Tax ID # 05-445671  
**ON-SITE SEWAGE DISPOSAL SYSTEM**  
**HOWARD COUNTY HEALTH DEPARTMENT**  
**BUREAU OF ENVIRONMENTAL HEALTH**

SUBDIVISION: Scaggsville Knolls LOT NUMBER: 1

ADDRESS: 11205 Melvin Court PROPERTY OWNER: NVR Inc.

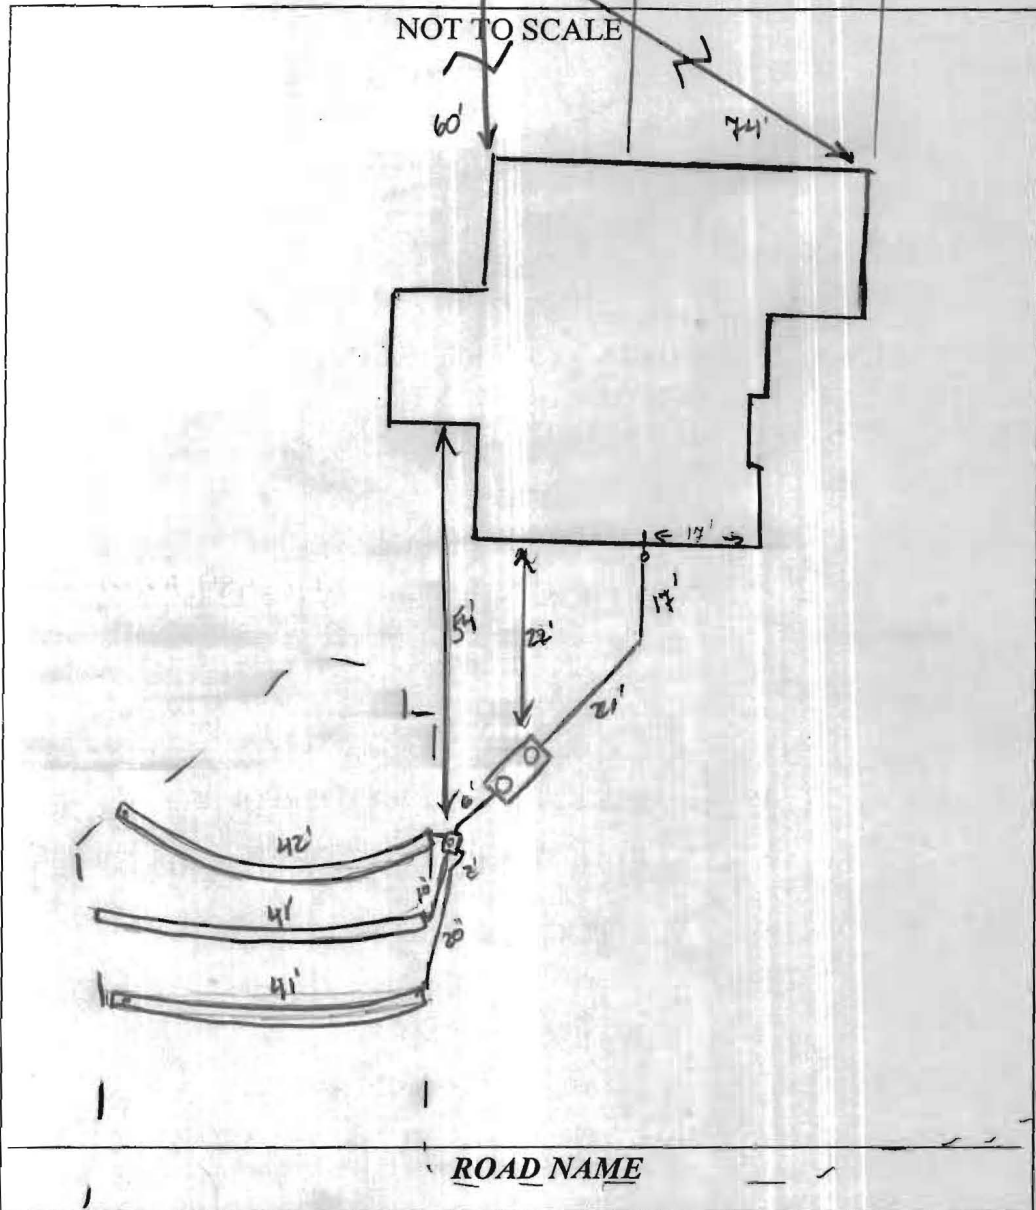
SEPTIC TANK CAPACITY (GALLONS): <sup>2000</sup>~~1500~~ OUTLET BAFFLE FILTER REQUIRED

LINEAR FEET OF TRENCH REQUIRED: <sup>103</sup>  
125 2' wide  
INT @ 4'  
Bottom @ 8'

10/29/10 Set S.T. per approved BP plan. Trench specs changed as shown on permit. Install 3# rebar on contour on top part of S.T.A. stay inside S.A. stakes. Spacing feet of dwelling > 250'. Tanks must be 2000g (KW)
